SERVICE BULLETIN SB00.17

Machines/Models:LX31/41/50 4WD **Serial Numbers:** 1410 -2746

PURPOSE: Enhance Brake Durability

PROCEDURE REQUIRED: Install Orifice Fitting, Replace the Counterbalance Valves and Adjust the Bi-Directional Relief Valves

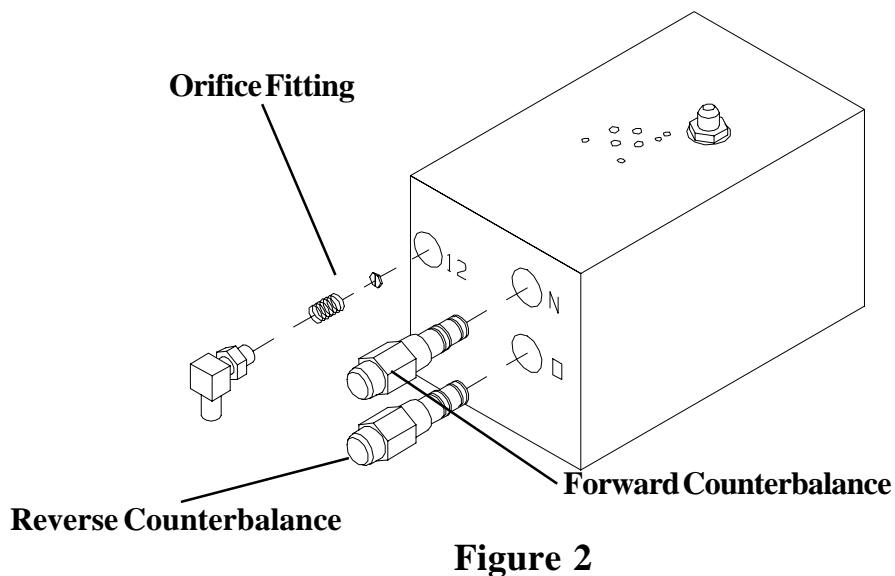
1. Locate the Left (Right) Bi-Directional Relief Valve (see Figure 1).
2. Loosen the Bi-Directional Relief Valve locknut (remove tamper proof cap if applicable).
3. Turn the valve clockwise until it gently rests against the seat.
4. Turn the valve counterclockwise 4 1/4 turns.
5. Torque the locknut to 3 Ft. Lbs (4 Nm).
6. Repeat steps 1 through 5 for the Right Rear Bidirectional Relief.

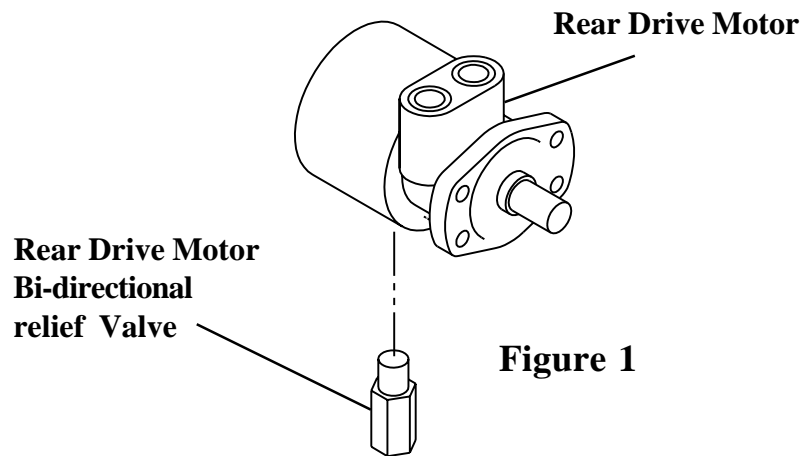
1. Locate the Forward (Reverse) Counter Balance Valve (see Figure 2).
2. Remove the valve from the valve block and discard.
3. Install the kit supplied valve (P.N. 014862-001).
4. Torque the valve to 45 - 50 ft lbs (47-58Nm).
5. Repeat steps 1 through 4 for the Reverse Counter Balance Valve.

1. Locate port 12 on the Main Hydraulic Manifold (see Figure 2).
2. Remove the Line at the fitting at Port 12.

3. Remove the fitting in Port 12 on the Main Hydraulic Manifold.
4. Insert the supplied spring and orifice (with the slot side out)(see Figure 2).
5. Reinstall the fitting and torque to 10 to 20 Ft. Lbs (13-26 Nm).
6. Reinstall the line and torque to 18 to 20 Ft. Lbs (22-26 Nm).
7. Perform Pre-Operation and Safety Inspection as instructed in the Operator Manual to ensure proper operation of machine.
